HIGHLAND CITY DEVELOPMENT ADMINISTRATION BOARD AGENDA

2. ACTION: Final Plat Approval for Ridgeview Plat M

DATE: March 31, 2025
TO: Development Administration Board
FROM: Rob Patterson, City Attorney / Planning & Zoning Administrator
SUBJECT: **Final Plat Approval:** Ridgeview Plat M
TYPE: **LAND USE (ADMINISTRATIVE)**

GRADING & DRAINAGE PLAN

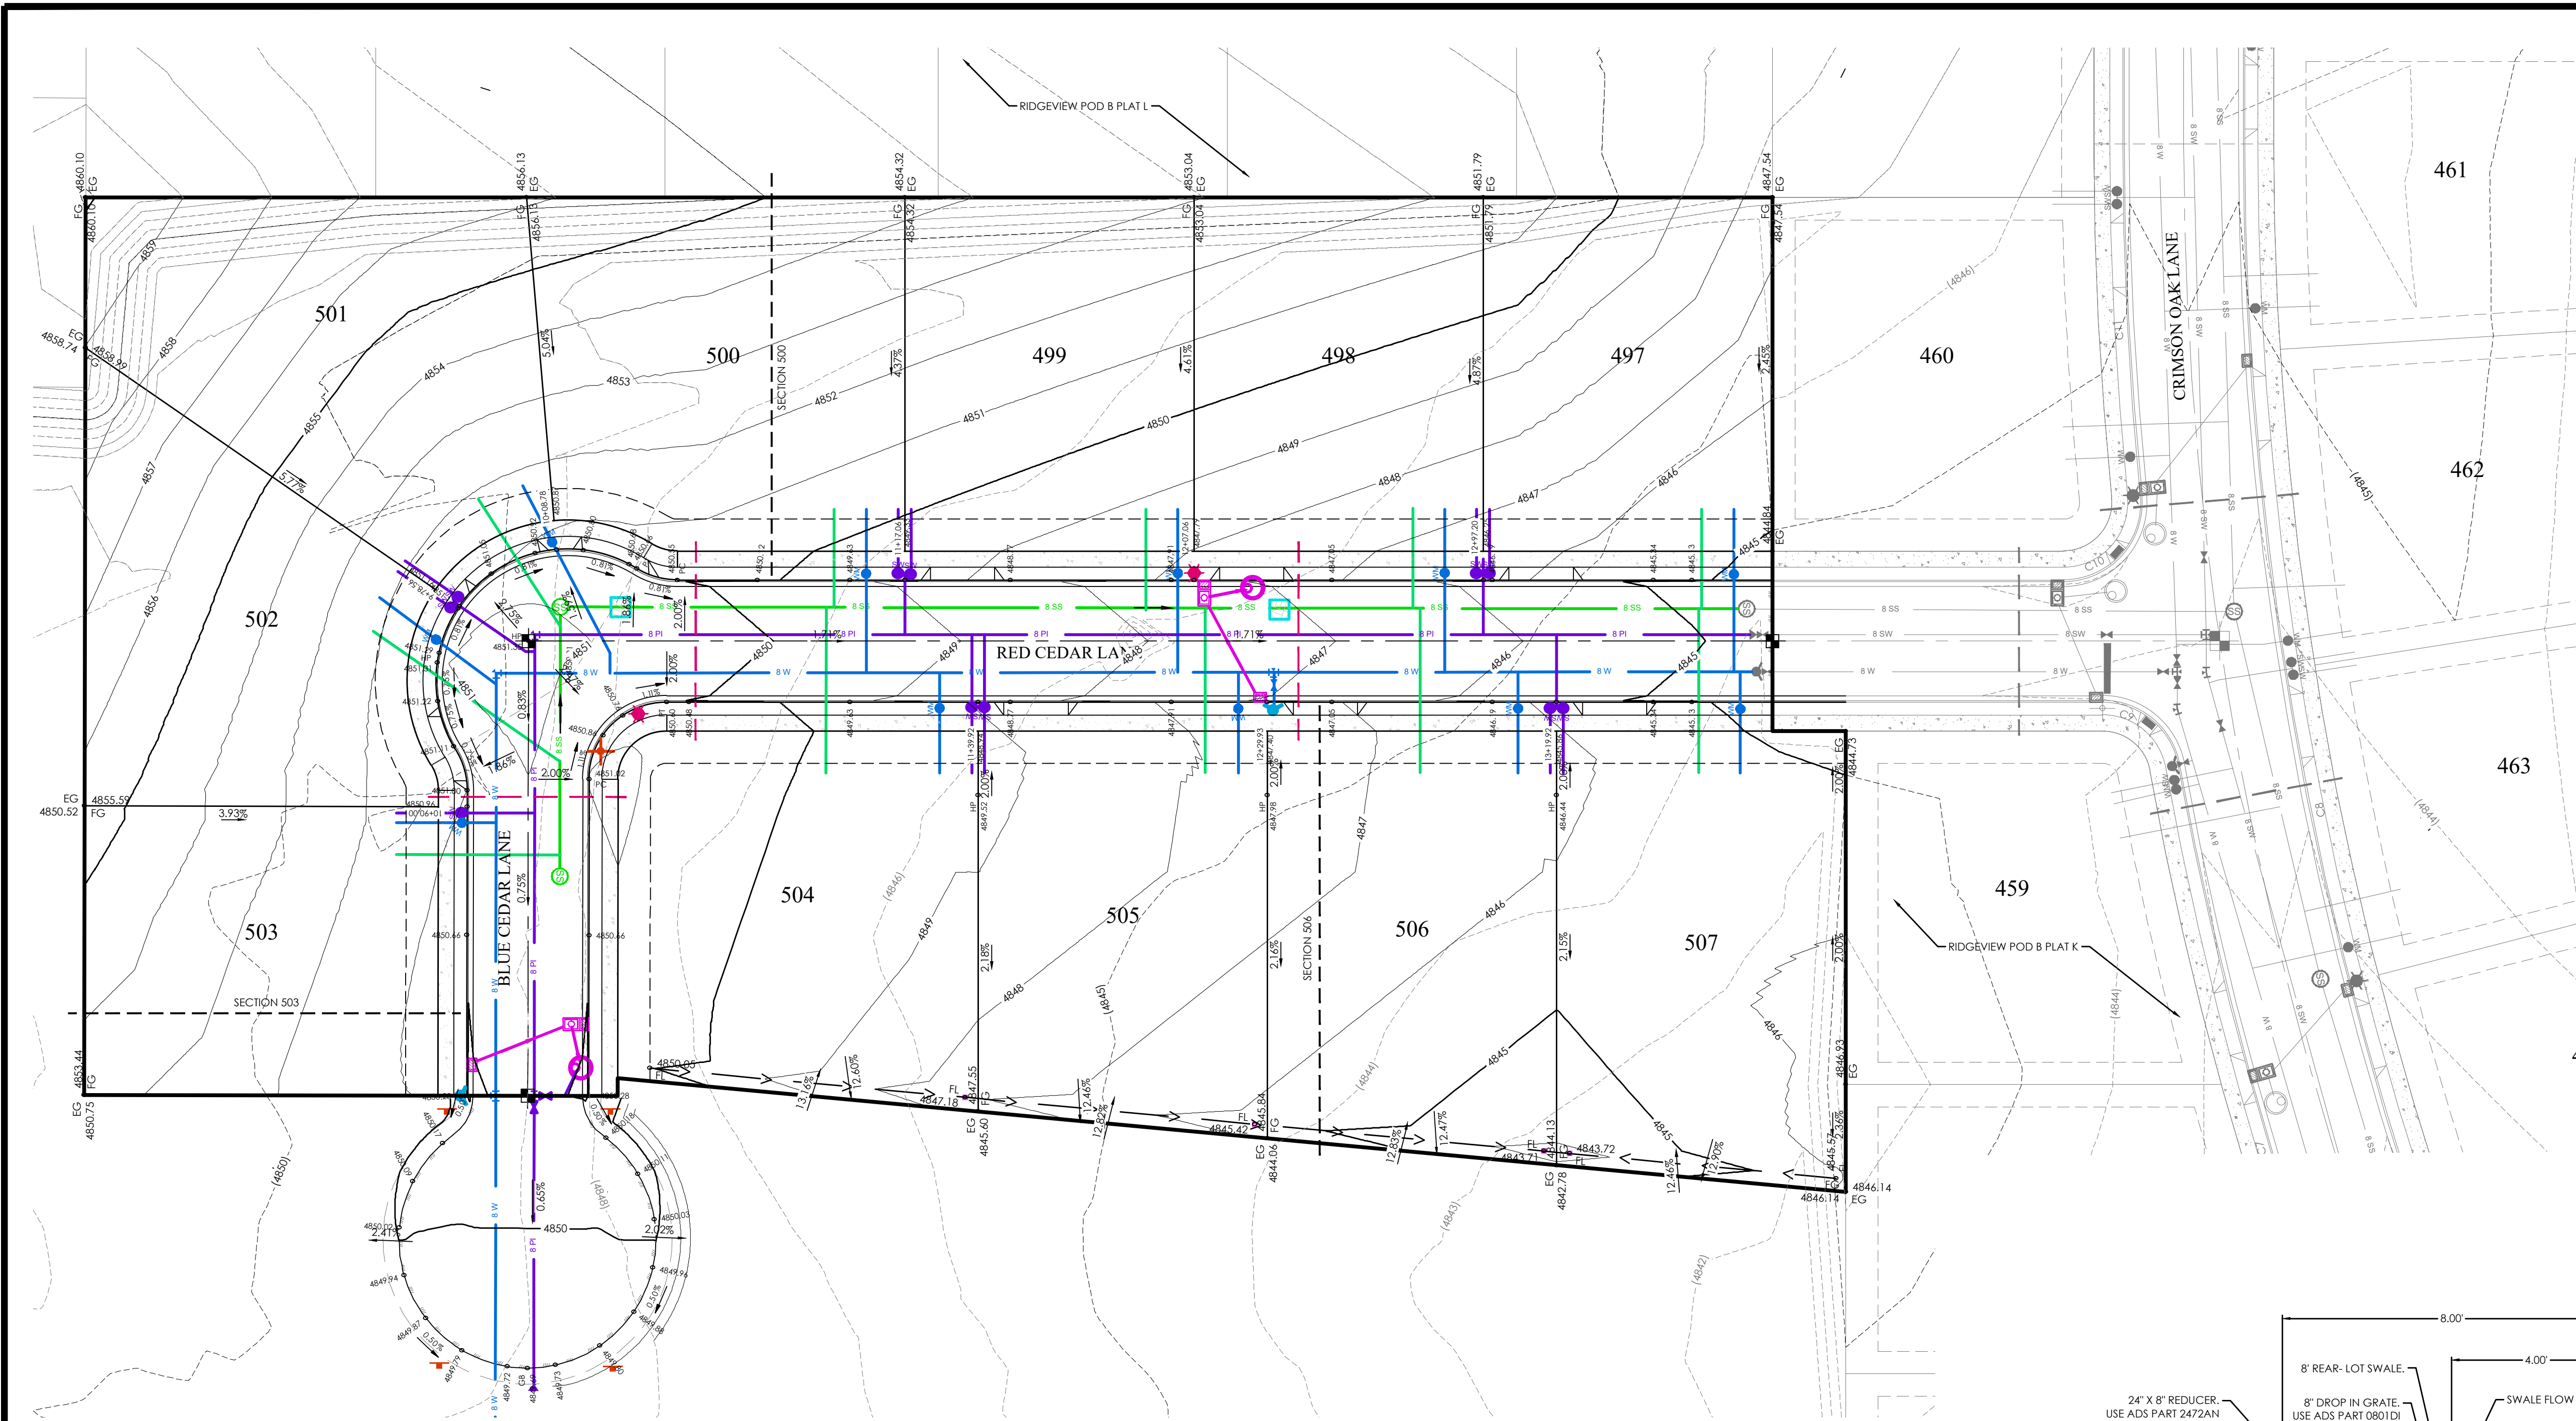
- The subdivision improvement plans for utilities and drainage, with the revisions dated 3.21.2025 to the storm drain report and sheet C4.0 Grading & Drainage, conform in major respect to City standards and the stipulations of approval of the preliminary plat. Staff's Review Comments issued March 31, 2025, address and correct the remaining issues.
- Developer has provided water shares for the property within the development that will remain private property.

SUMP DRAIN DETAIL (REAR-LOT) - PROFILE VIEW

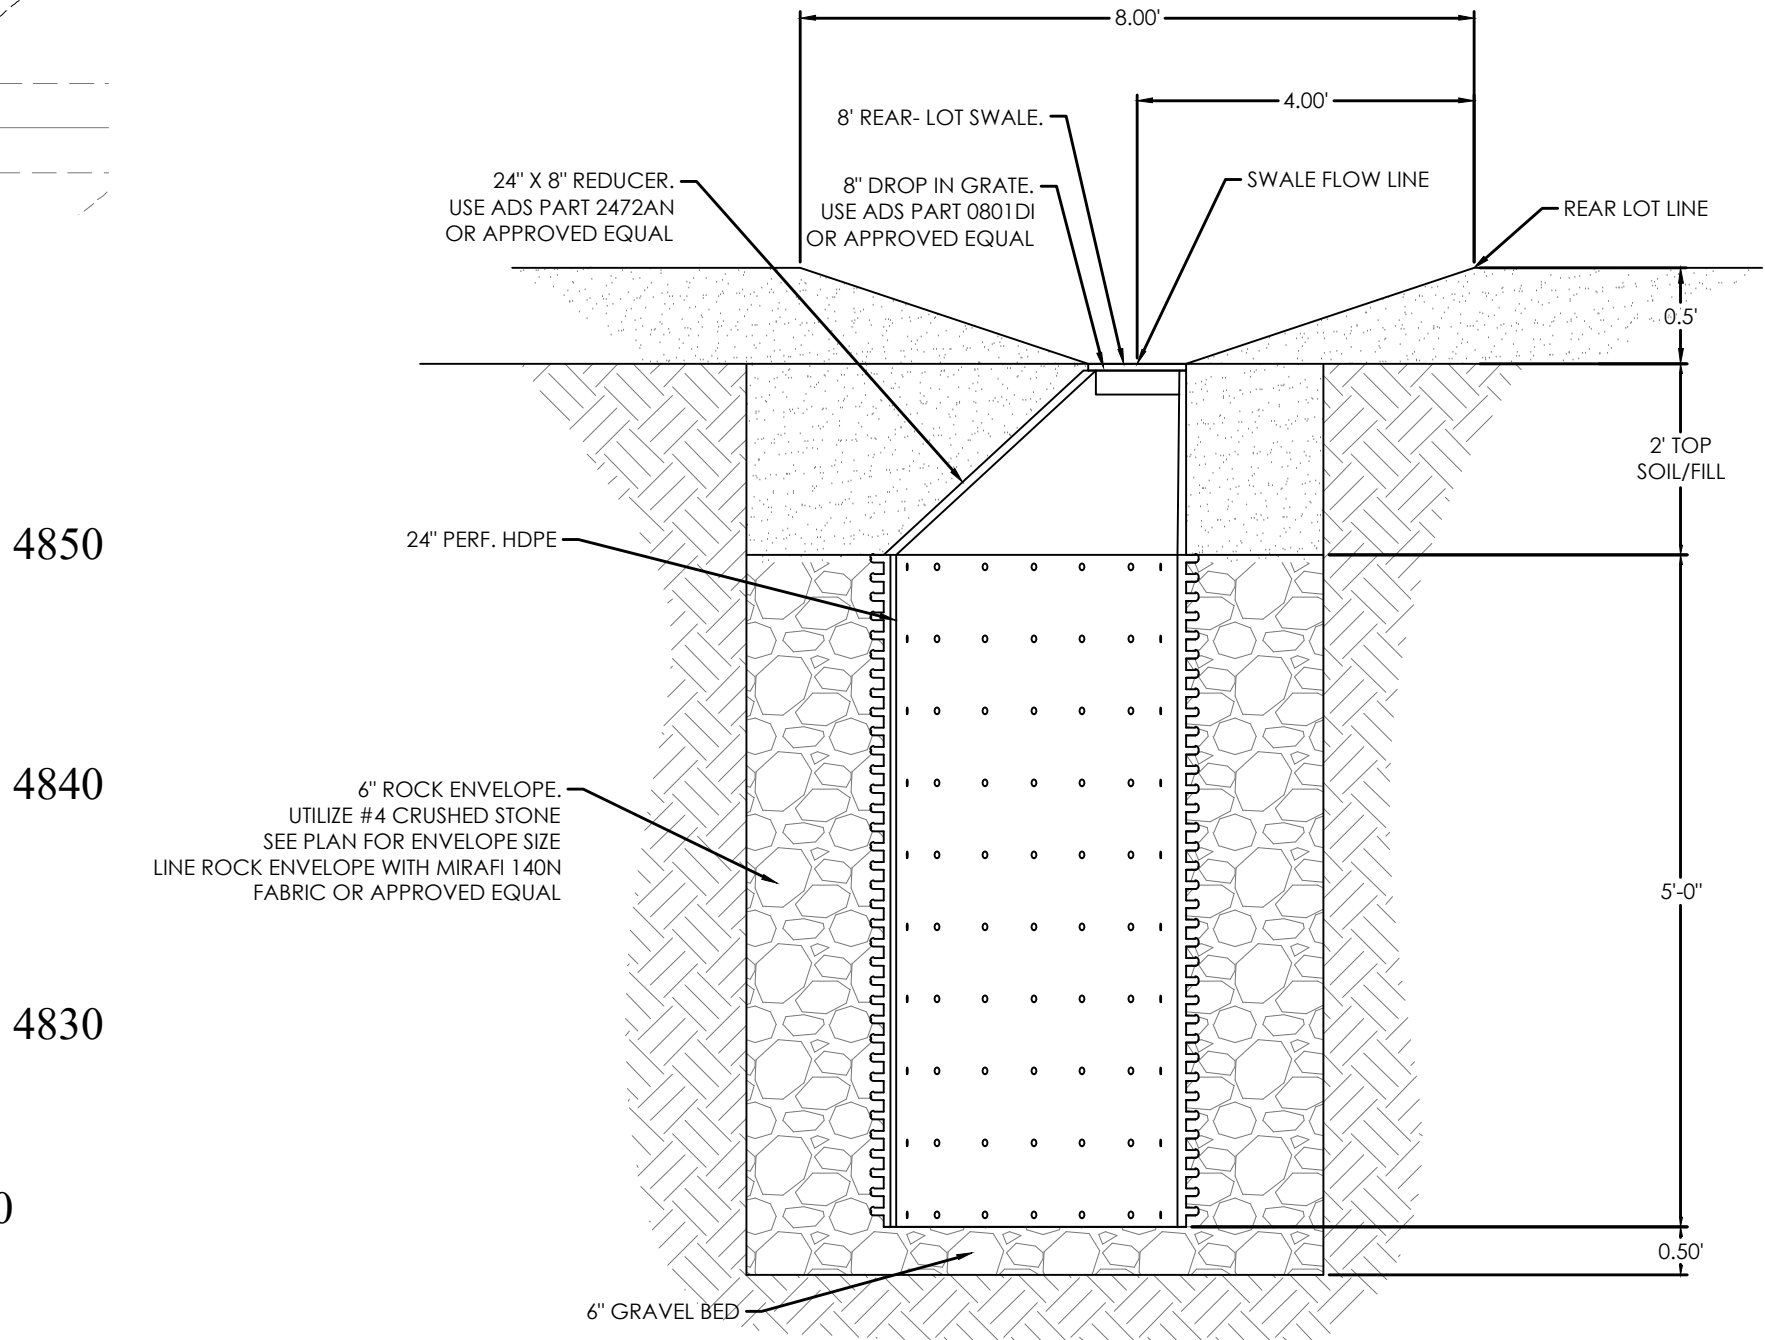
- Nate addressed comment 3A or 5 from before about the sump. Print details are so small and unreadable. The overall depth is also another concern. Nate asked the questions of why we changed the sump detail from approved in K to a different in L

- Nate broke down his issue with the sumps as follows
 - Needs to be readable
 - Very broad statement in the depth of the sump
 - Call out the height and pipe and gravel on the plans (Nate is worried about what will happen when the landowner takes responsibility for the property.

- Commissioner Abbott brings up the point that if they would just use the sump plans from K it would get approved.
- Ben said that they will make the change to follow K plans.

- Nate asks that the drainage report and calculations will show this change.
